**SUPPLEMENTARY COUNCIL REPORT**  
SOUTHERN REGIONAL PLANNING PANEL

<b>PANEL REFERENCE &amp; DA NUMBER</b>	PPSSTH-116 – DA.2021.1549
<b>PROPOSAL</b>	Subdivision of land (Googong Neighbourhoods 3, 4 & 5) into 1398 Torrens title residential lots, 14 super lots for future residential development, 5 Neighbourhood Centre lots, boundary adjustment, all associated subdivision construction works, roads, tree removal, signage and landscaping and relocation of Shearing Shed.
<b>ADDRESS</b>	Part of: Lot 42 DP 754881, Lot 776 DP 1230282, Lot 2 DP 1231713, Lot 3 DP 1149329, Lot 10 DP 754881, Lot 1263 of DP 1283369, Lot 7 DP 1246784, Lot 996 of DP1276892, Lot 1605 DP 1266000, Lot 12 DP 1266001, Lot 13 DP 1266001 and is commonly known as 36 Googong Road, Googong, NSW.
<b>APPLICANT</b>	Googong Township Pty Ltd
<b>PANEL MEETING DATE</b>	7 September 2022
<b>SUPPLEMENTARY ISSUES</b>	Intersection design Old Cooma Road and Bunyip Drive Noise affected lots Retention of values of an Aboriginal Heritage Item

Plan 308534CA300 showing intersection without signals.

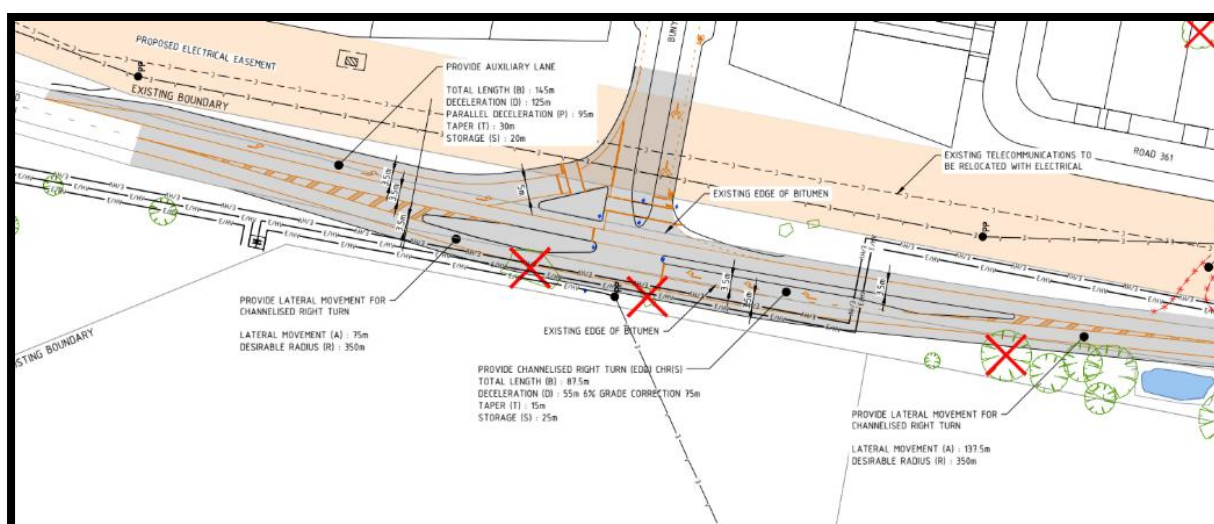
Plan 308534CA300 shows the proposed intersection design of Old Cooma Road and Bunyip Drive. Council, the developer and Transport NSW support an intersection in the location shown on the proposal plans.

Through the assessment process plans were submitted by the Applicant showing a signalised intersection in this location. These had not been assessed by Transport for NSW and do not form part of the approval issued by them.

At the panel meeting of 7 September members sought a greater degree of certainty and confirmation that the design as proposed is acceptable to the relevant parties. The note and condition have subsequently been removed.

A report has been prepared for Council determination on 24 September 2022 recommending a signalised intersection. It is anticipated that the Applicant will lodge a Modification Application to amend this consent, should the application be approved, to include signals. That Modification Application will require referral and concurrence by Transport for NSW.
